CONTRACT CHANGE ORDER NO. 230
SHEET 2 OF 3

MARK	DATE	DESCRIPTIONS	BY	CH'D	CCO#
2	01/05/12	FIELD MODIFICATION OF SUSPENDER BRACKETS	GB	MN	230
1	12/31/09	SUSPENDER BRACKETS	GB	MN	104
0	02/20/09	SUSPENDER BRACKETS	GB	MN	104

SAN FRANCISCO OAKLAND BAY BRIDGE
EAST SPAN SEISMIC SAFETY PROJECT
SELF-ANCHORED SUSPENSION BRIDGE
(SUPERSTRUCTURE & TOWER)

SUSPENDER BRACKET DETAILS NO. 8

SUSPENDER BRACKET DETAILS NO. 9

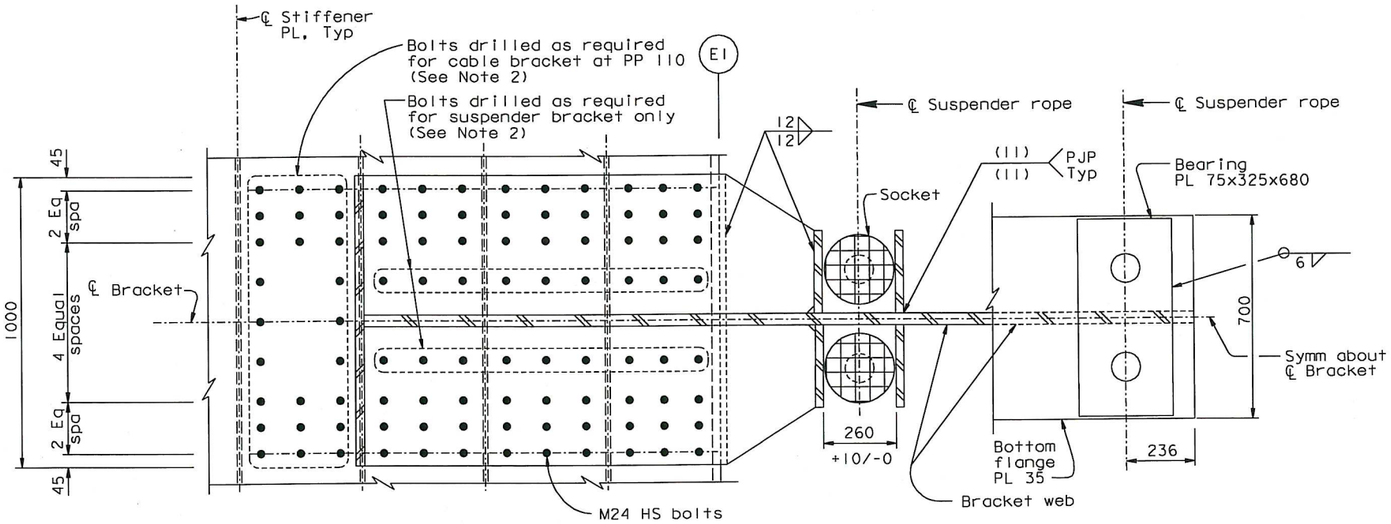
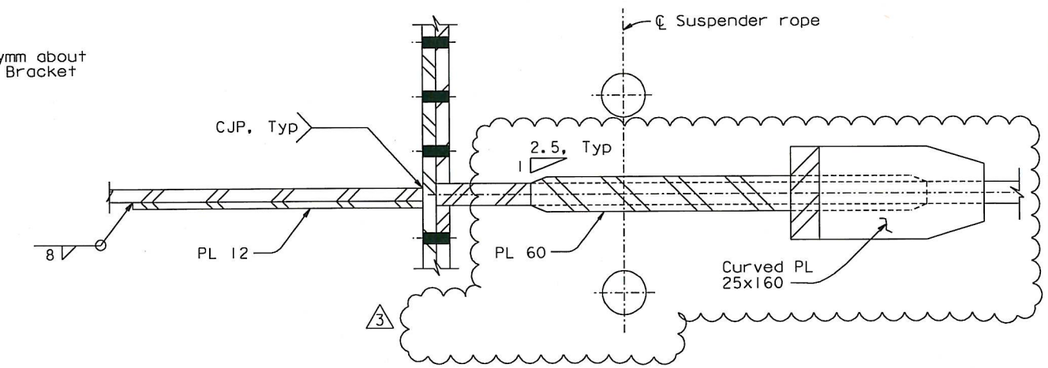
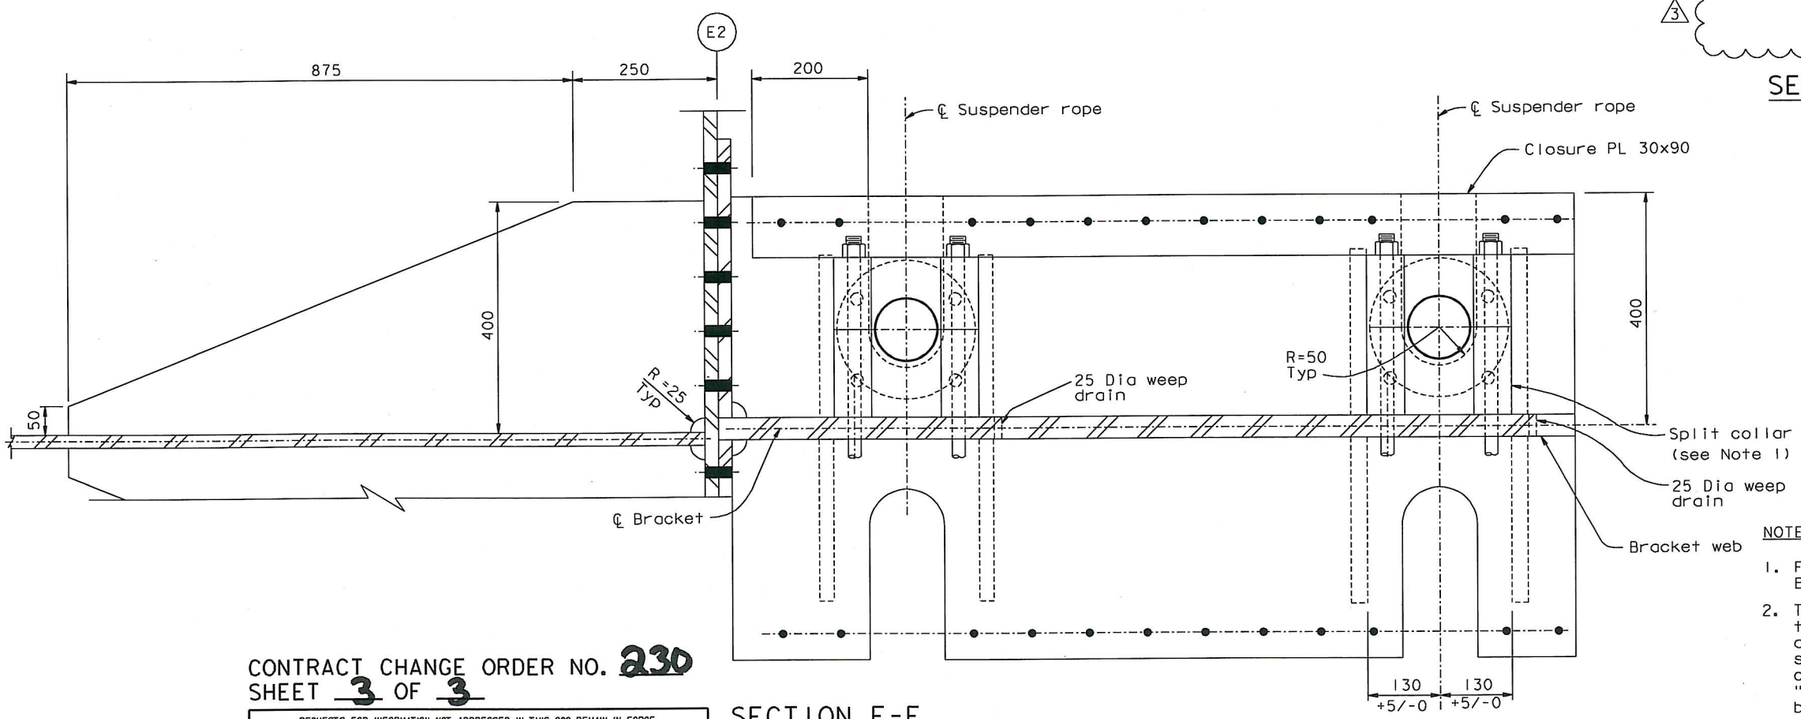
MARK	DATE	DESCRIPTIONS	BY	CH'D	CCO#
3	01/05/12	FIELD MODIFICATION OF SUSPENDER BRACKETS	GB	MN	230
2	06/11/10	SUSPENDER BRACKETS	GB	MN	1045I
1	12/28/09	SUSPENDER BRACKETS	GB	MN	104
0	02/20/09	SUSPENDER BRACKETS	GB	MN	104
